ADDENDUM NO. 1
BASEBALL AND SOFTBALL COMPLEX RENEWAL
FOR GADSDEN STATE COMMUNITY COLLEGE
Architect Job No. 23-66
November 30, 2023
ACCS No. 2023 063 GSCC

The Plans and Specifications are hereby amended. The following supersedes all contrary and/or conflicting information and is made part of the contract documents.

1 LANDSCAPE PLAN
Scale: 1" = 20'-0"

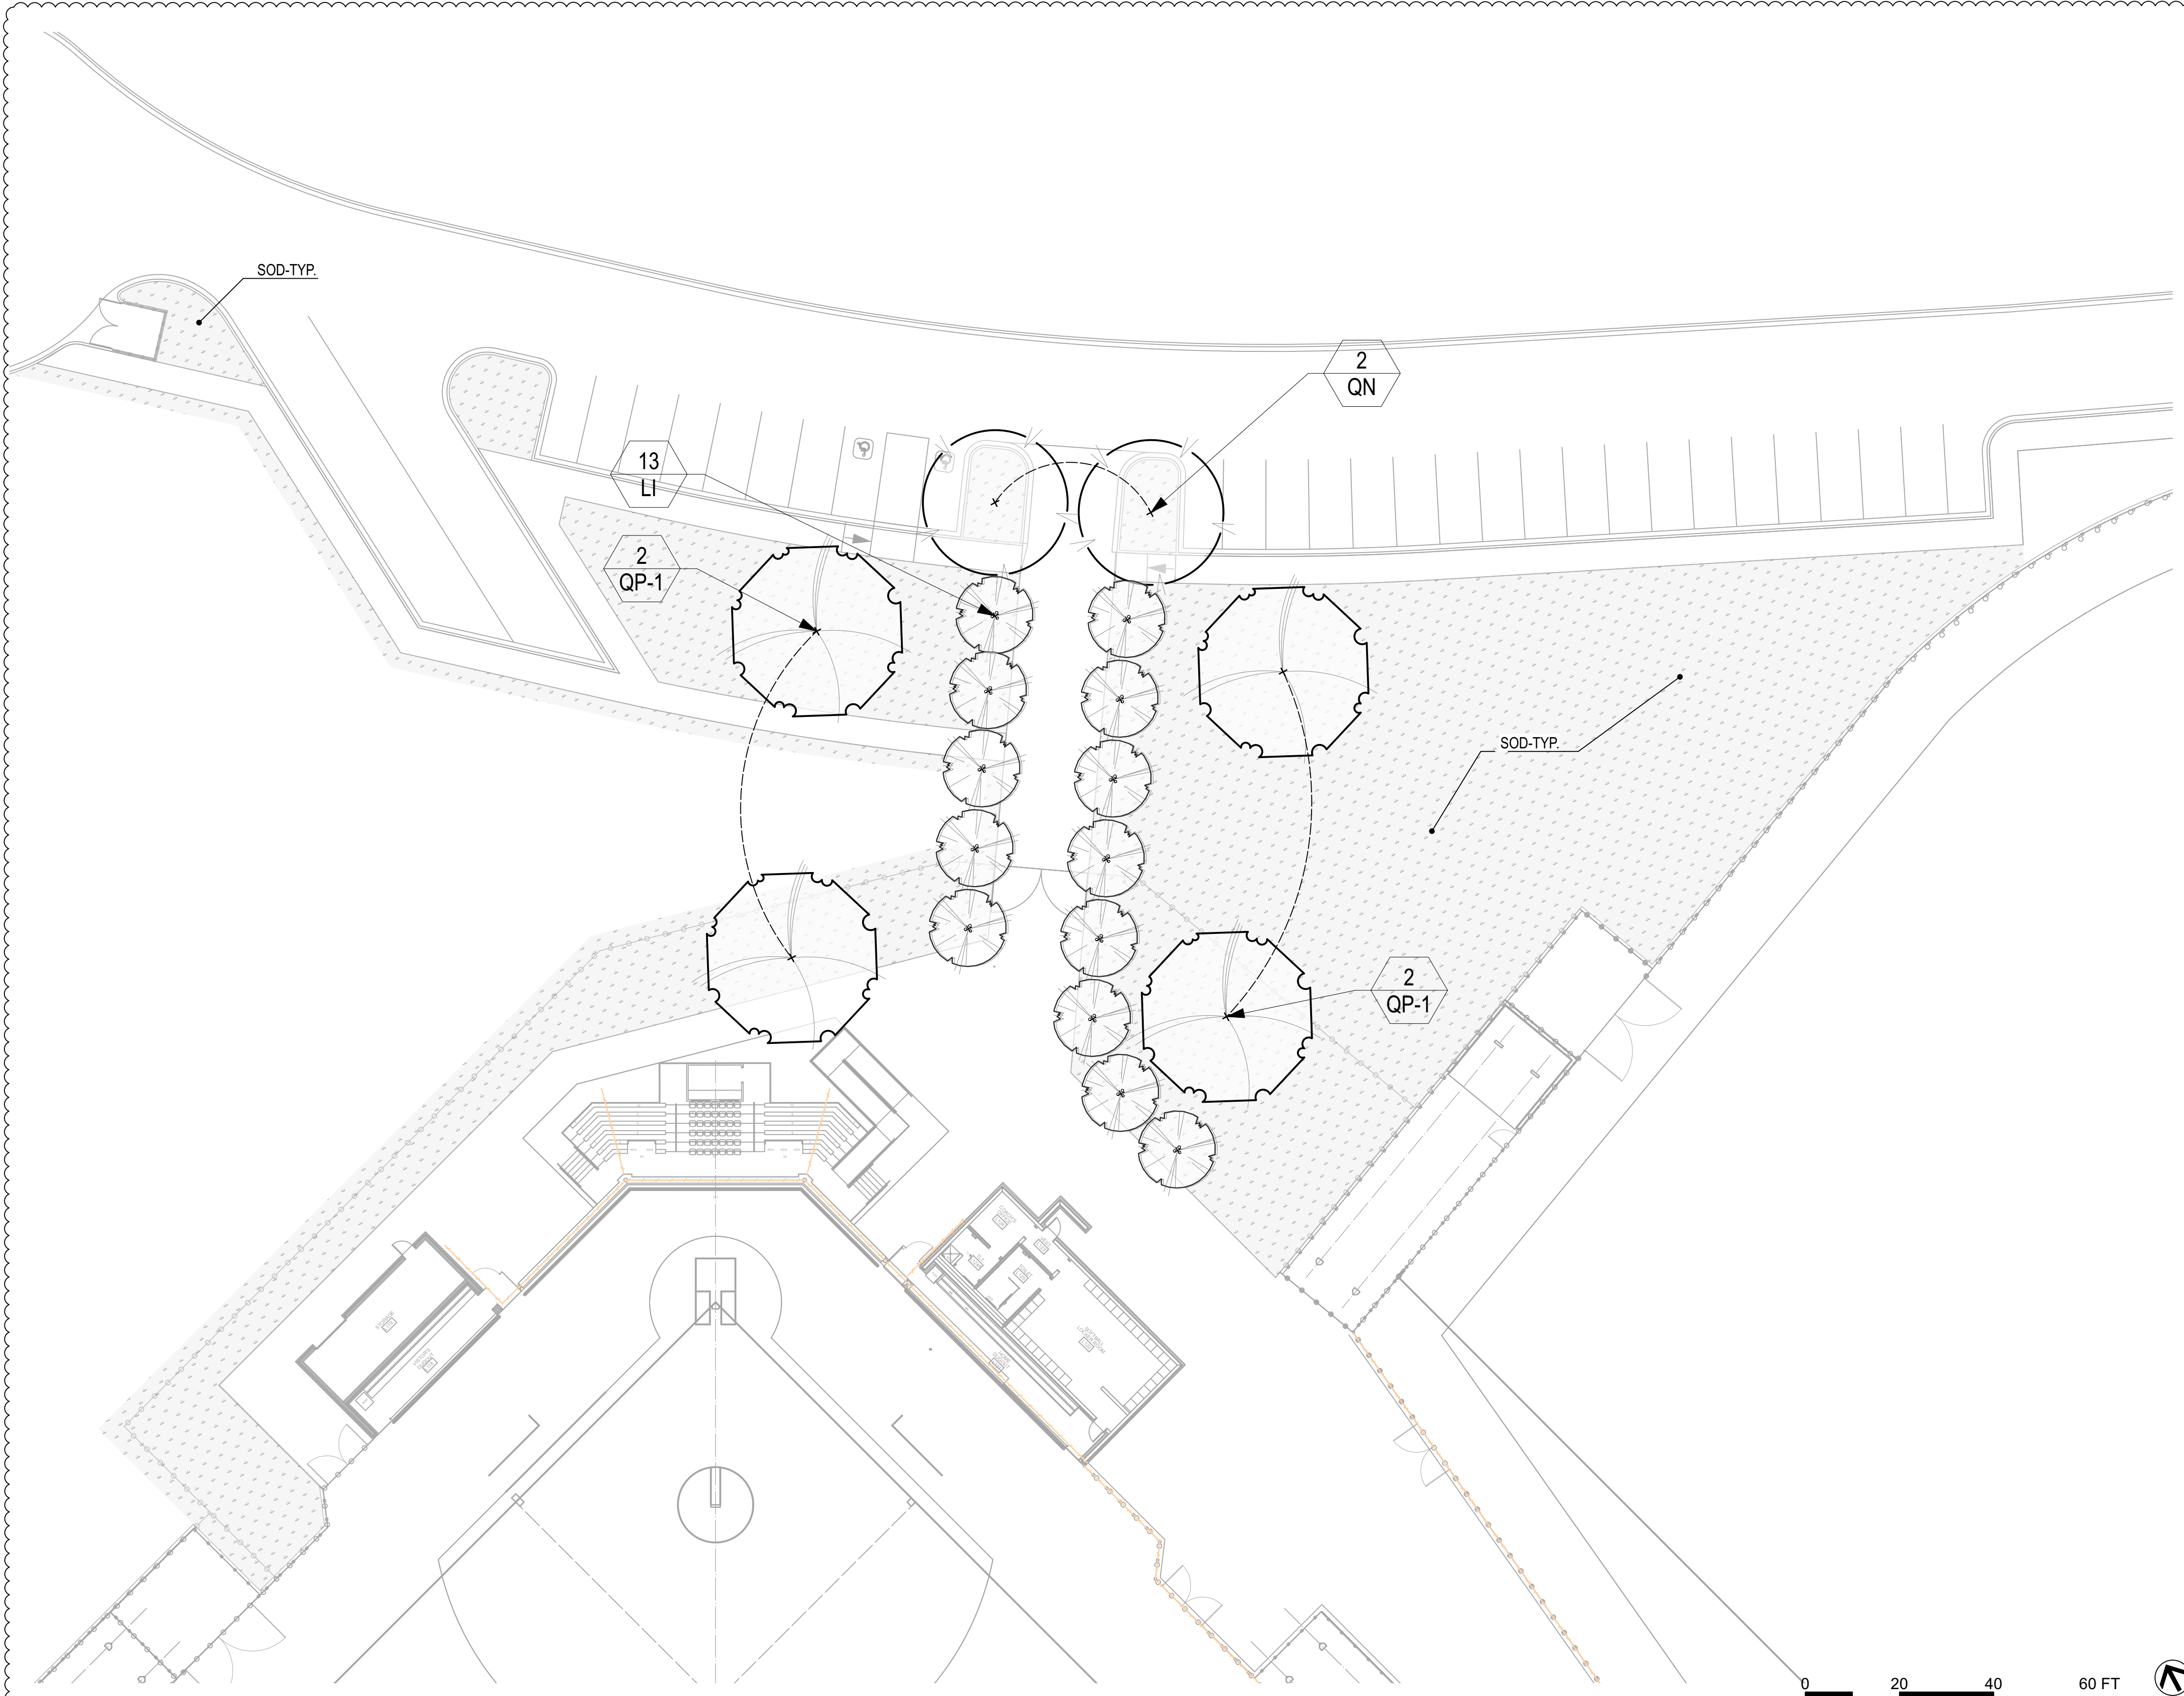
- A. Revised sheet to remove note, “SEED TO LIMIT OF DISTURBANCE.”
 - B. Revised sheet to add additional sod areas at entrance.
12. Sheet **L8.0** – IRRIGATION PLAN:

1
L8.0
IRRIGATION COVERAGE PLAN
Scale: 1" = 20'-0"

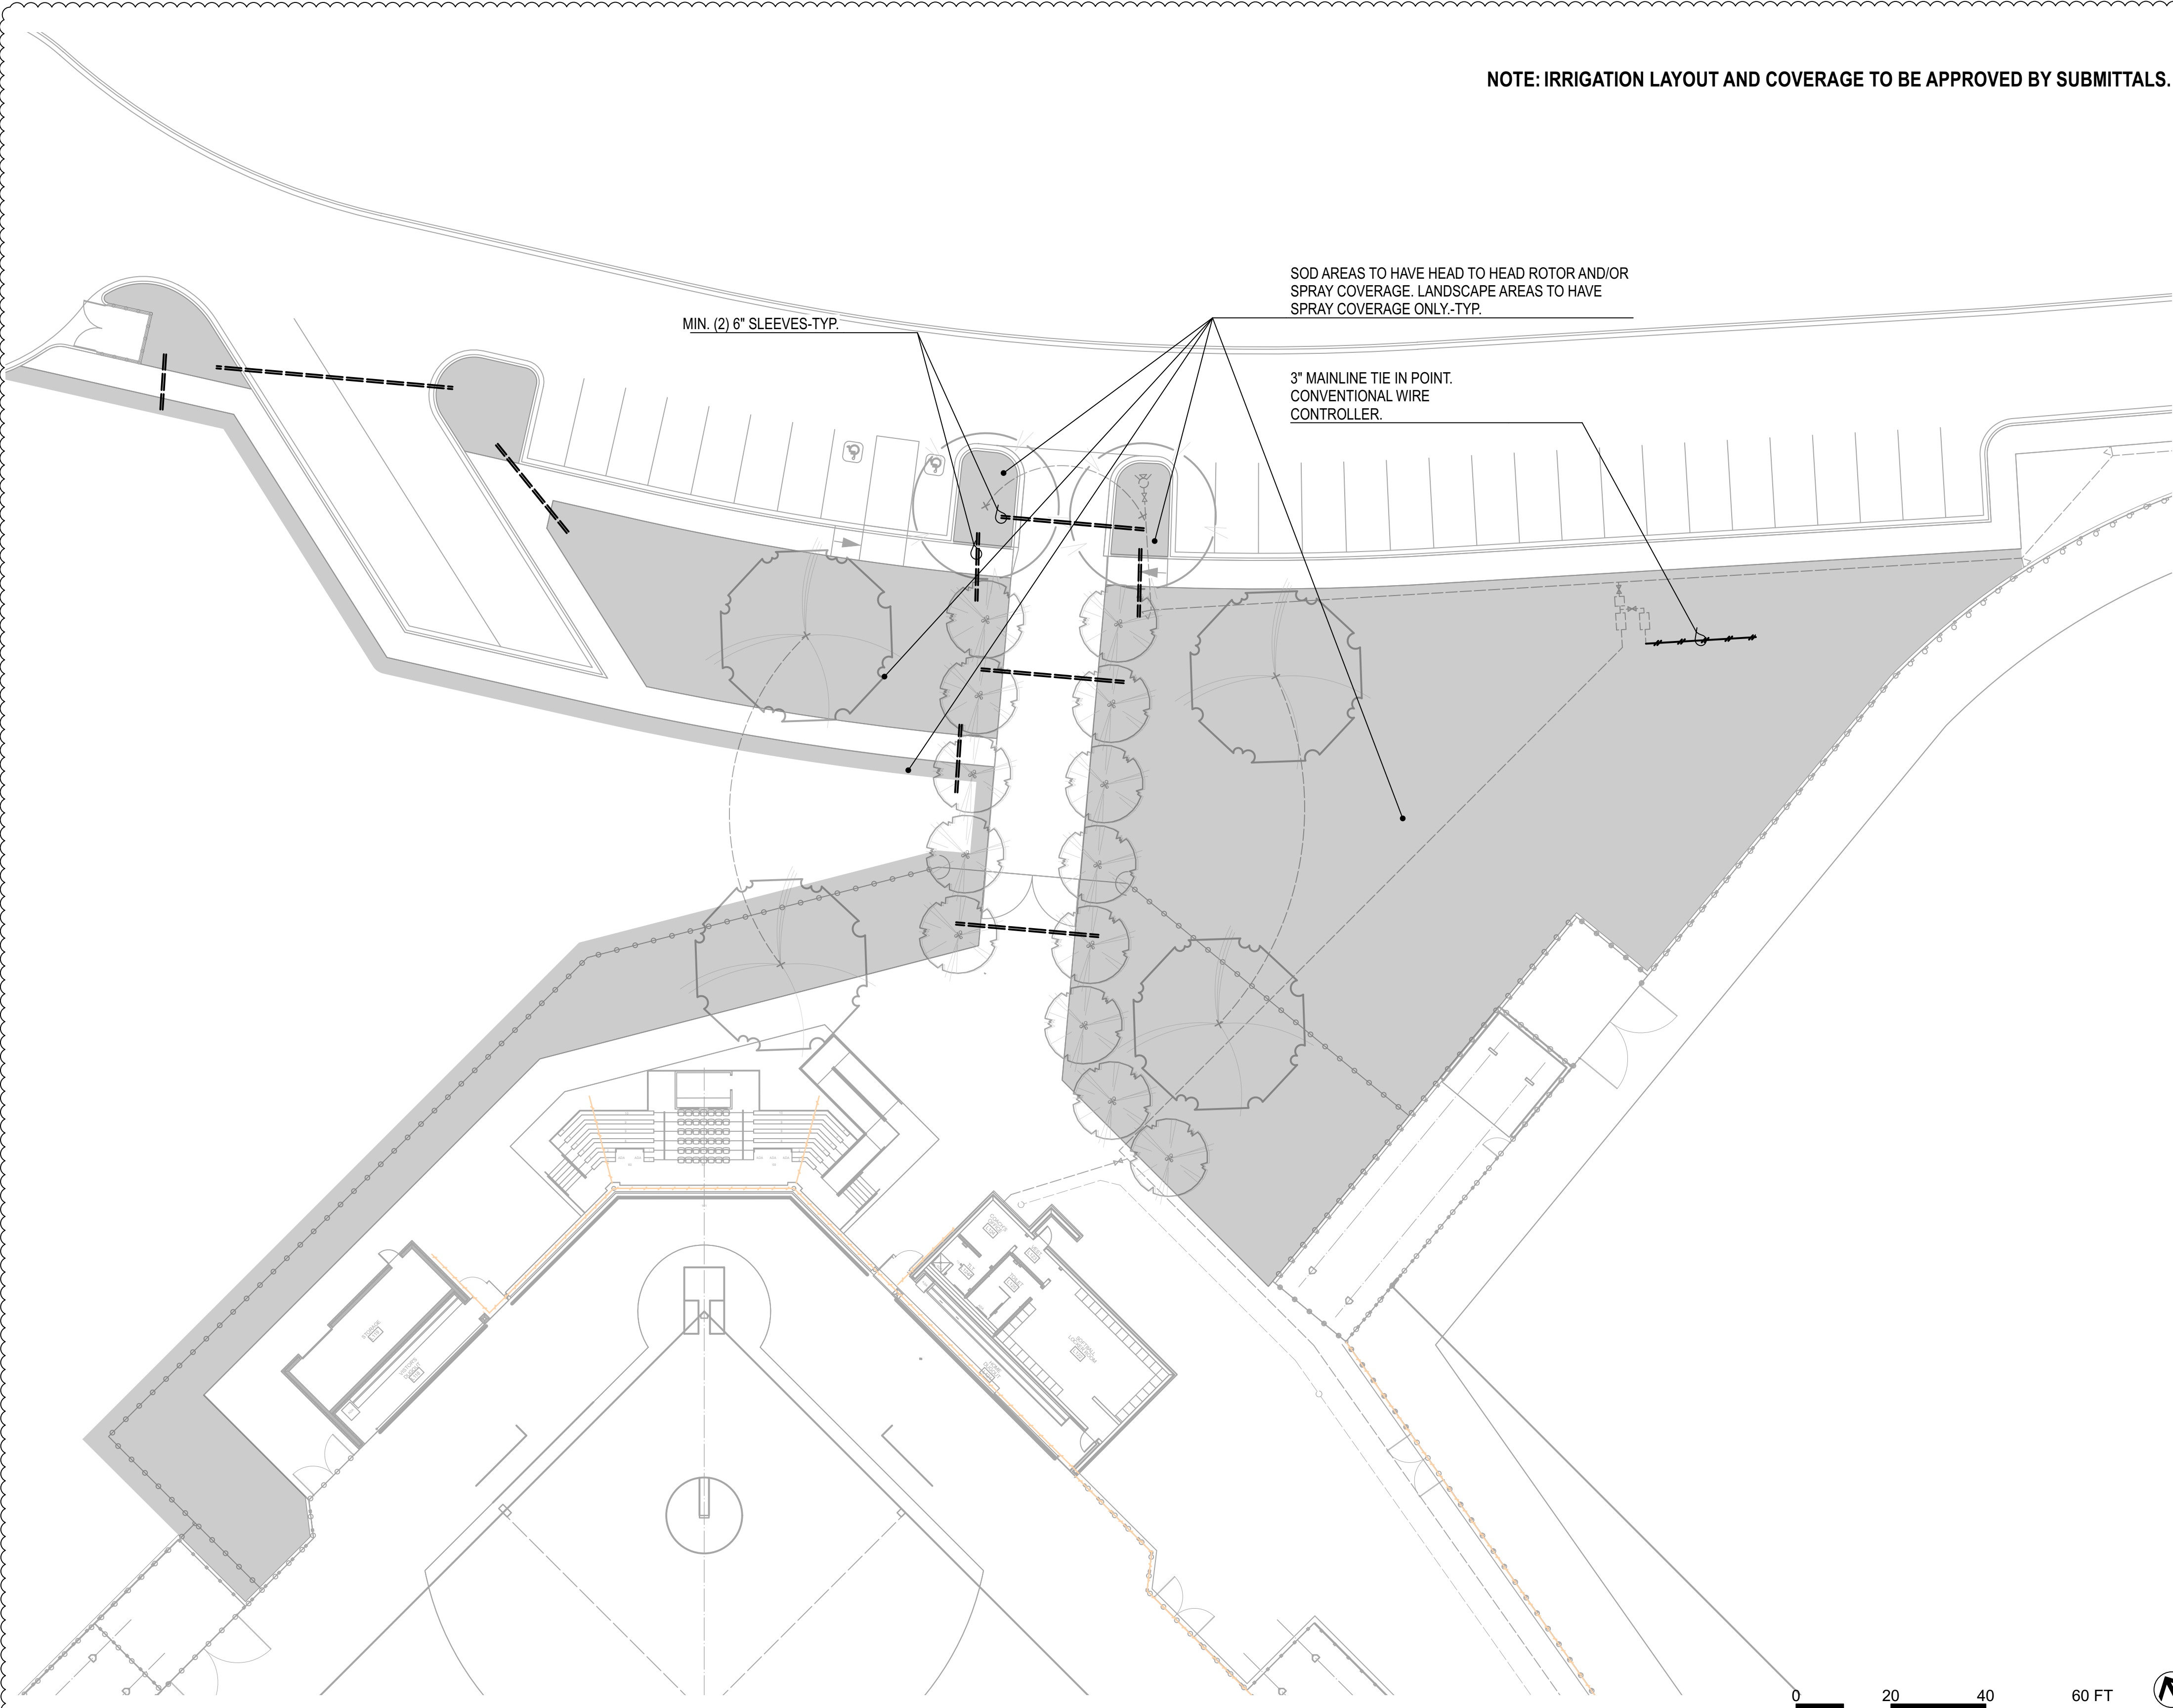
- A. Revised sheet to add note, “SOD AREAS TO HAVE HEAD-TO-HEAD ROTOR AND/ OR SPRAY COVERAGE. LANDSCAPE AREAS TO HAVE SPRAY COVERAGE ONLY. - TYP.”
 - B. Revised sheet to add note, “3” MAINLINE TIE IN POINT. CONVENTIONAL WIRE CONTROLLER.”

- C. Revised sheet to add additional coverage areas and sleeves.
13. See Sheets **E0.2**, **E0.5**, **E0.6**, **E1.0**, **E2.1**, **E4.1**, & **E4.2** for revisions.
